PRODUCT CHANGE NOTIFICATION

Select SRN Series Semi-shielded Power Inductors and SRP Series Shielded Power Inductors

Carrier Tape and Reel Temporary Change to Alternate Supplier

IC22077

2.1 Comparison of appearance

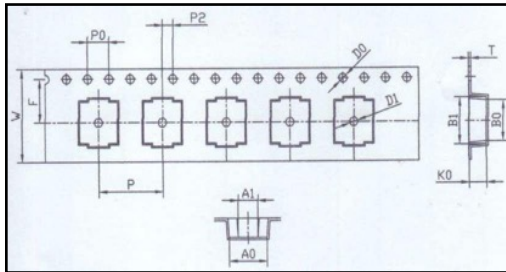
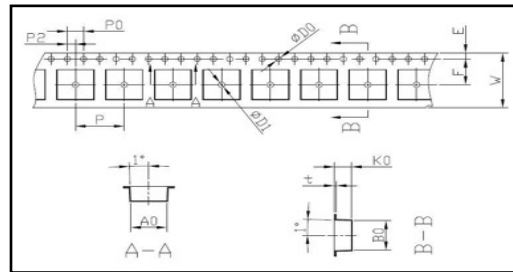
Series	Type	Appearance	Difference
SRN5020TA, SRN5040TA, SRN6045TA	Original		<p>Structure of pocket: Larger radius corner</p> <p>Color: Transparent, slightly white</p>
	Temporary		<p>Structure of pocket: Right angle corner</p> <p>Color: Transparent</p>
SRP4020TA, SRP4012TA	Original		<p>Structure of pocket: Stepped corner</p> <p>Color: Transparent, slightly white</p>
	Temporary		<p>Structure of pocket: Right angle corner</p> <p>Color: Transparent, slightly white</p>
SRP7028A, SRP7028AA, SRP6030VA	Original		<p>Structure of pocket: Stepped corner</p> <p>Color: Transparent, slightly white</p>
	Temporary		<p>Structure of pocket: Stepped corner</p> <p>Color: Transparent</p>
